Seismic Walkdown Checklist (SWC)

Equipment ID No. 1-1555-A7-015 Equip. Class¹² 10

Equipment Description SIS Pump Room Cooler A

Location: Bldg. Aux Floor El. 180' Room, Area RB 15

Equipment ID No: I-1561-E7-001-000 Equip. Class¹² _____

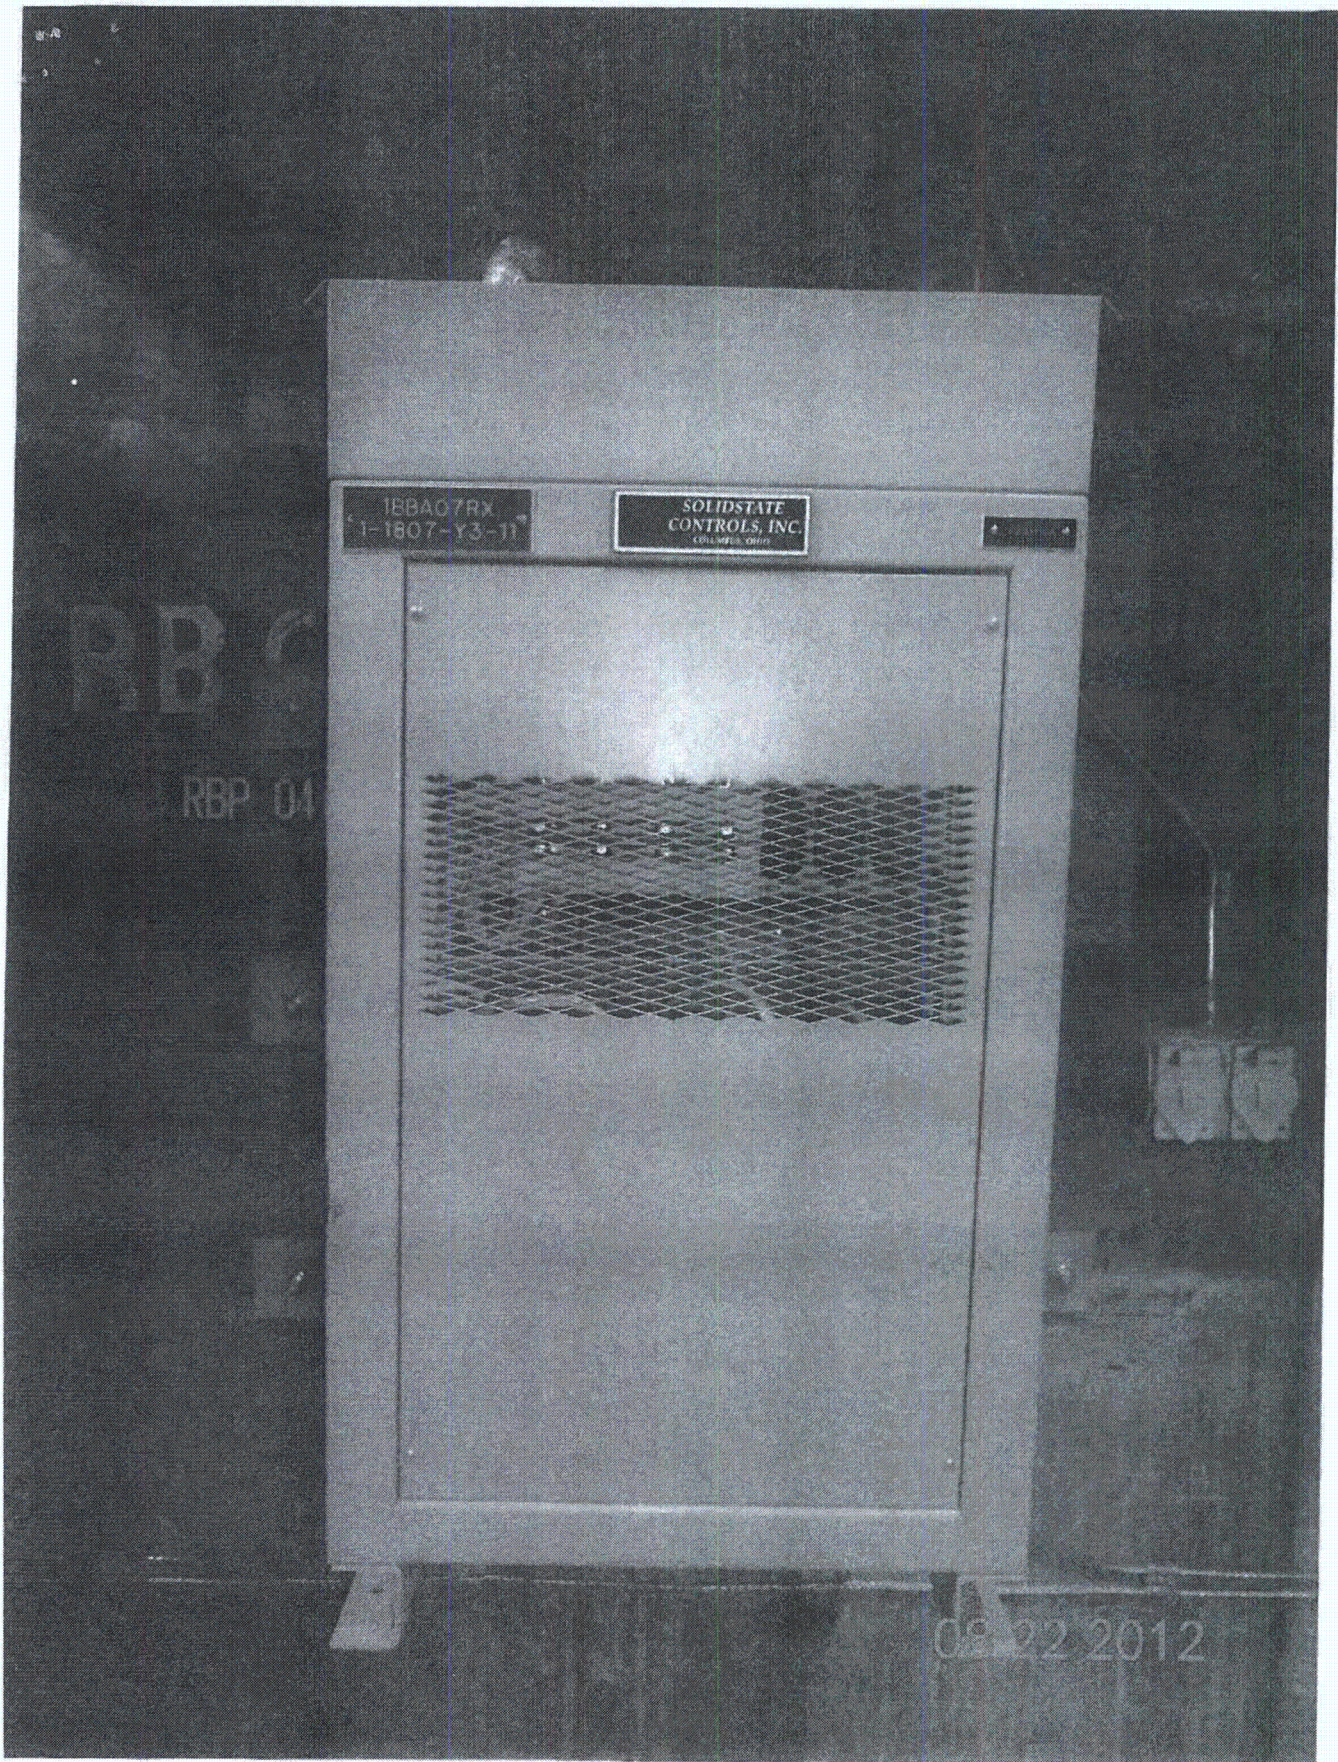
**SEVERAL BOLTS HAVE MODERATE CORROSION.
 ACCEPTABLE FOR SEISMIC CONCERNS
 SEE CR# 505960**

**MODERATE CORROSION ON BOLTS.
 ACCEPTABLE FOR SEISMIC CONCERNS
 SEE CR # 505960**

Equipment ID No. 1-1592-C7-002 Equip. Class¹² CHILLERS - CLASS II

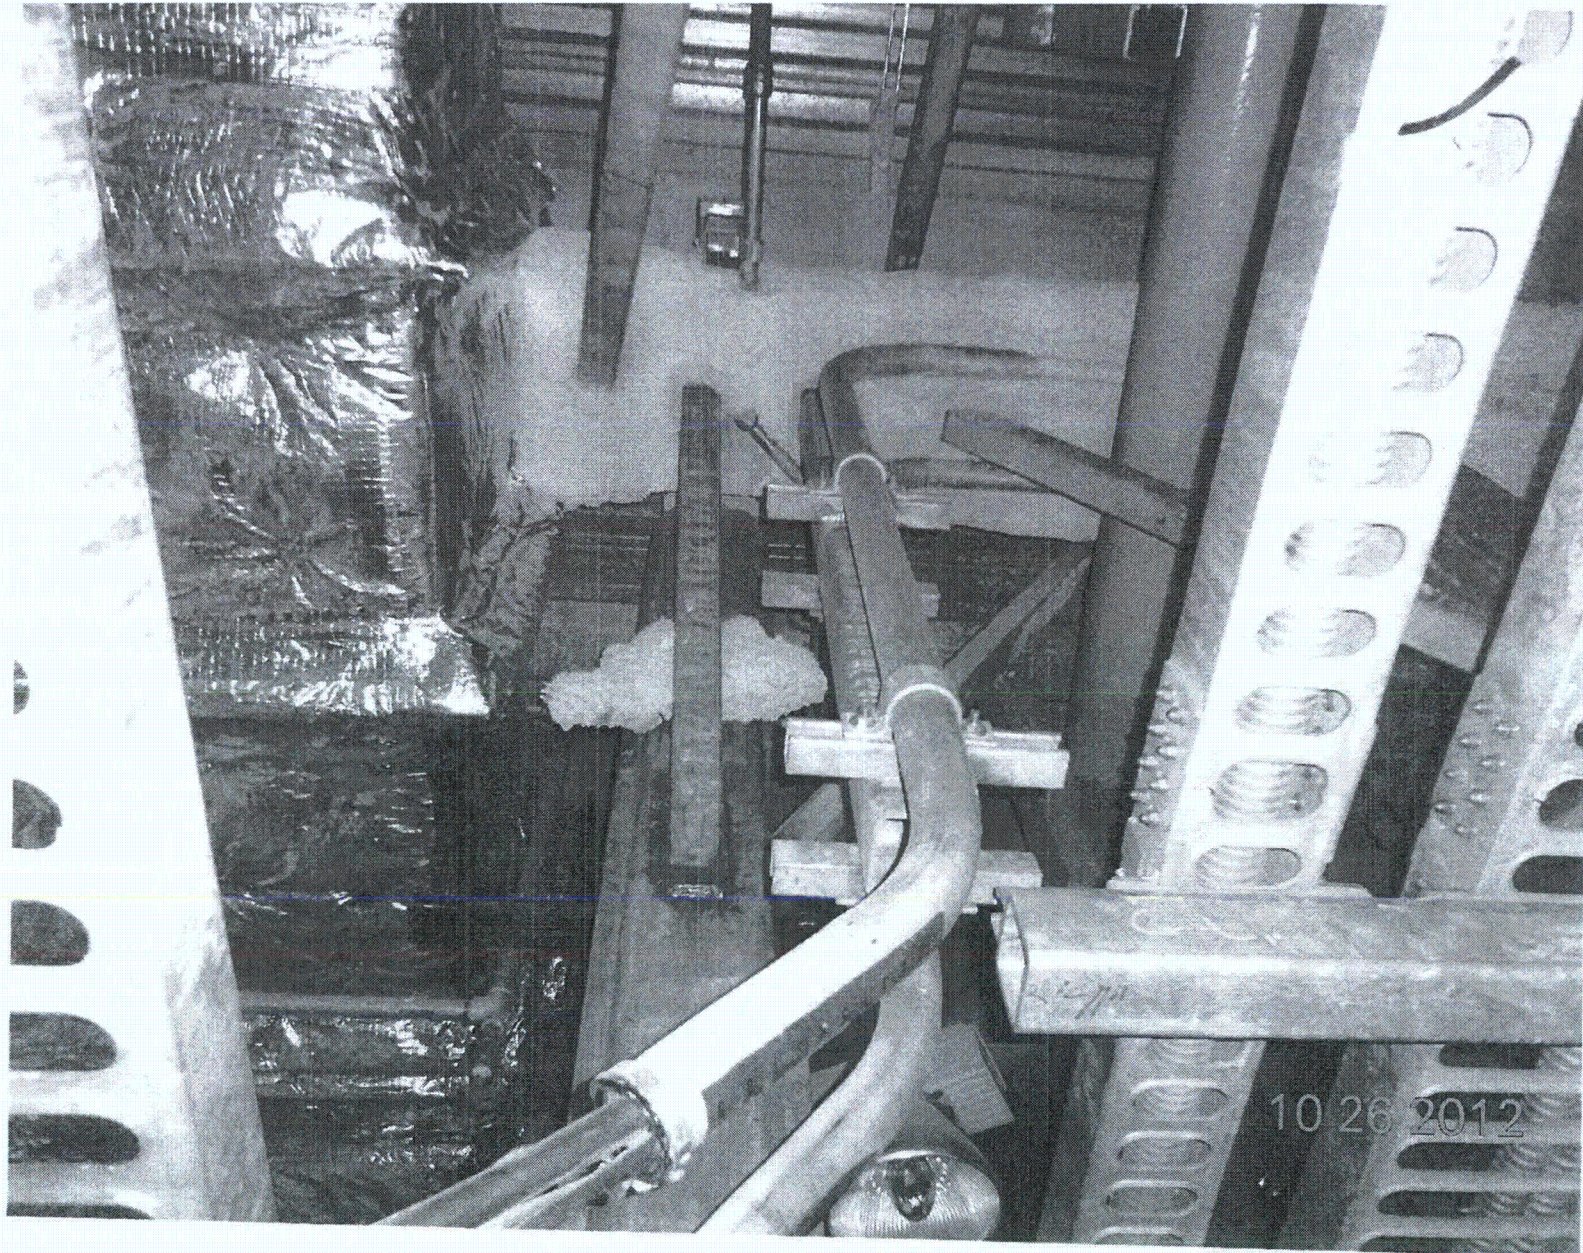
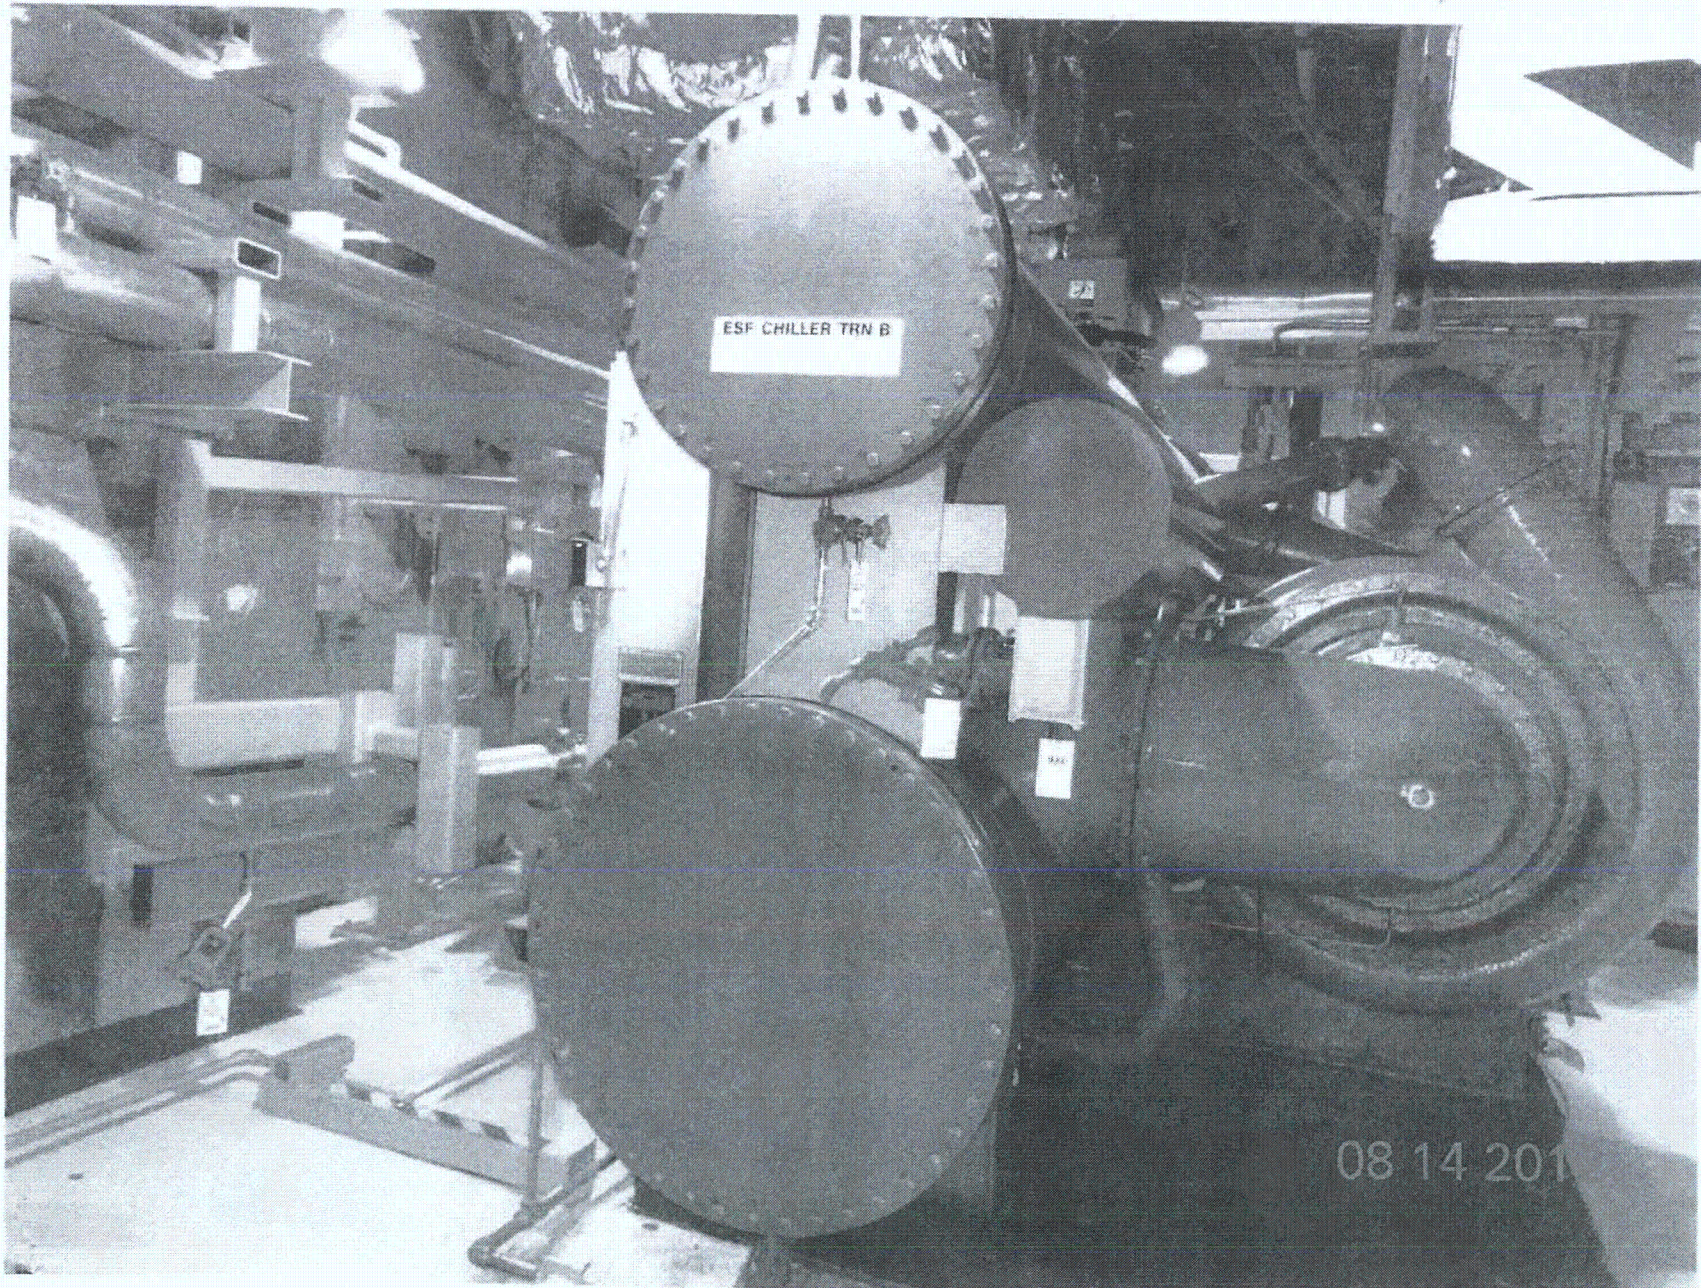
PIECE OF FIREPROOFING HAS FALLEN AND IS NOW RESTING BETWEEN THE VERTICAL POST AND DIAGONAL MEMBER OF A STRUCTURAL SUPPORT. NO POTENTIALLY ADVERSE SEISMIC INTERACTION WITH NEARBY EQUIPMENT. REF. CR 540131

Equipment ID No. 1-1593-B7-002 Equip. Class¹² 9

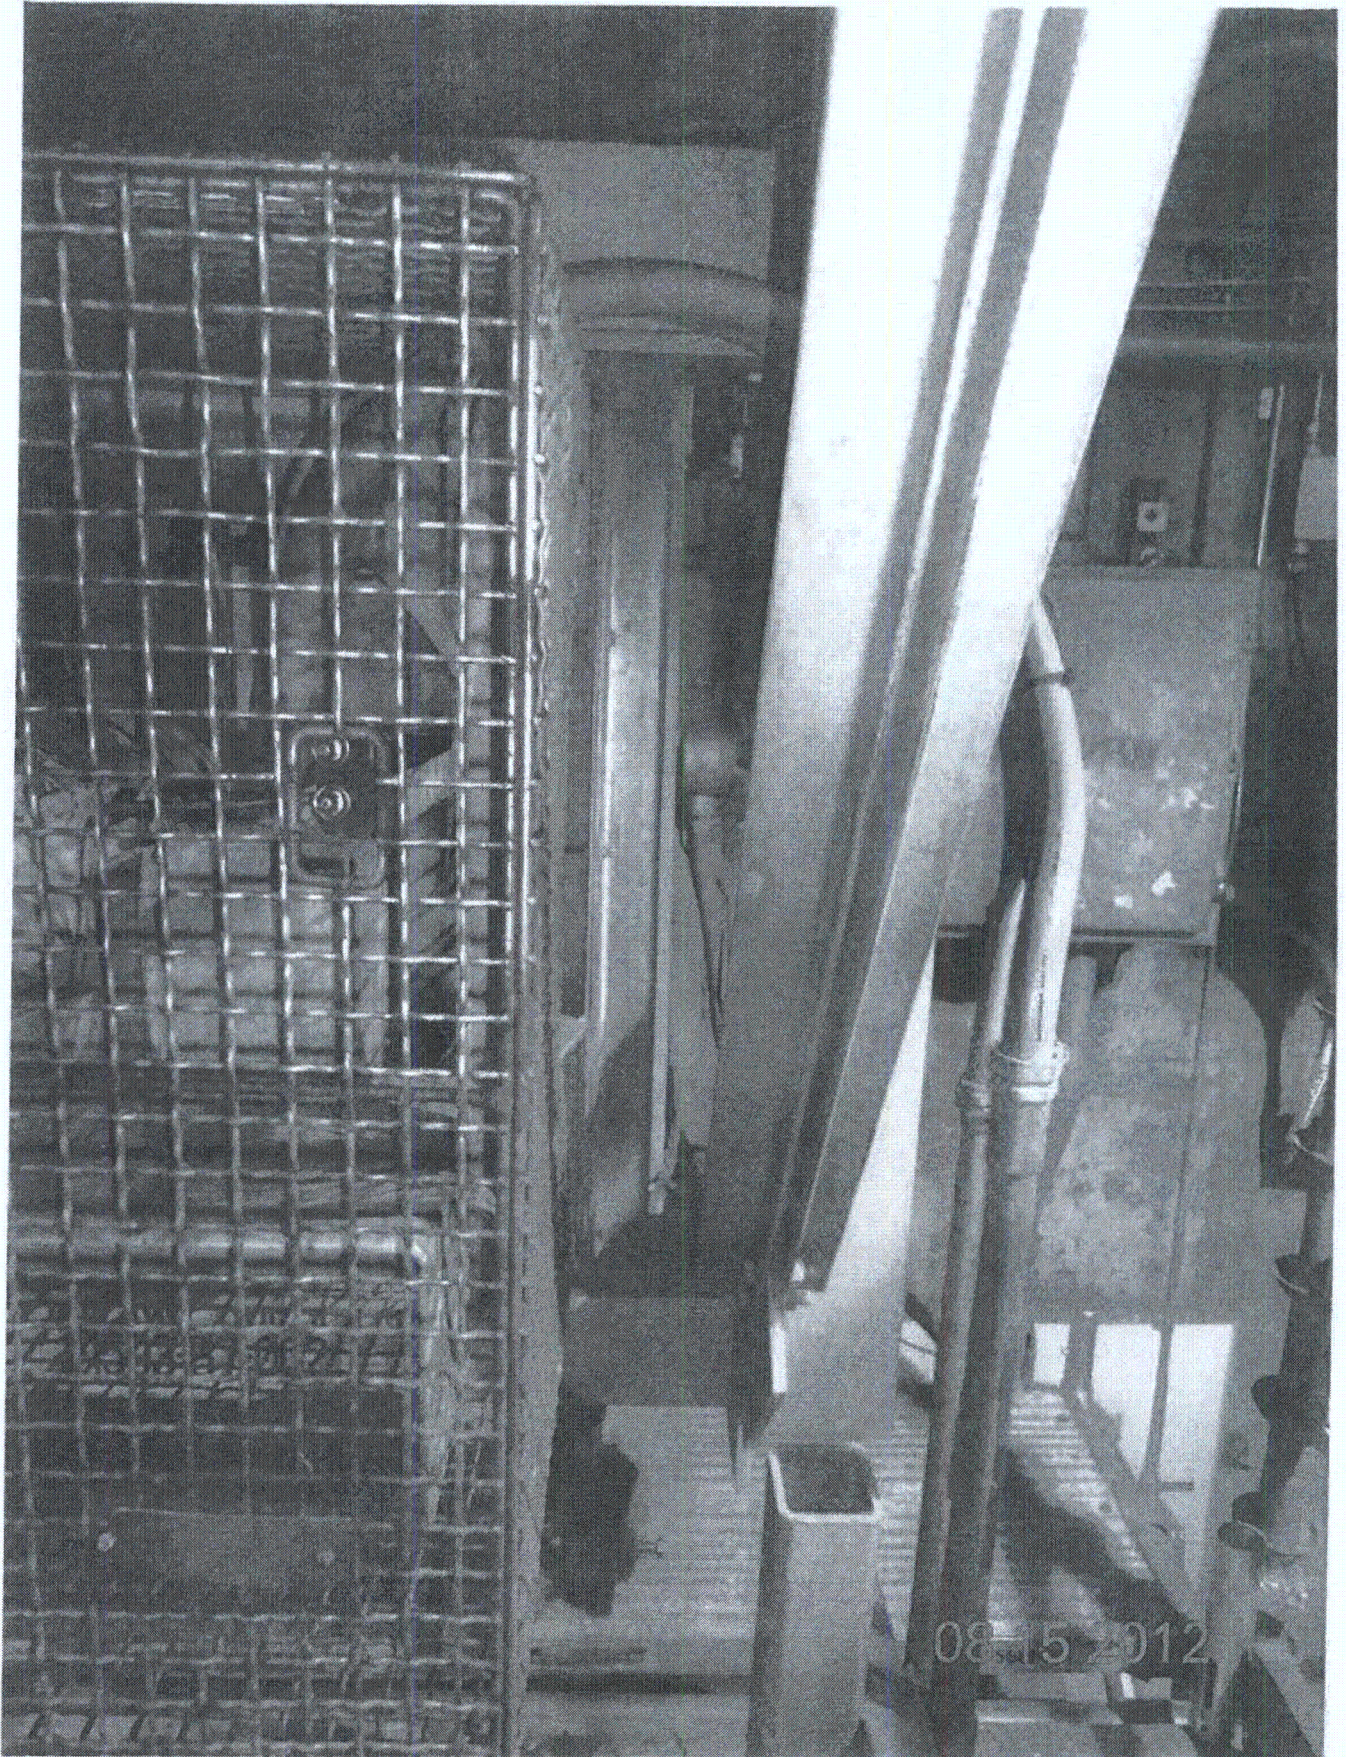
2. Is the anchorage free of bent, broken, missing or loose hardware? Y N U N/A
Two corner bolts on right side loose out of 16 bolts.

For loose bolts see CR 501650
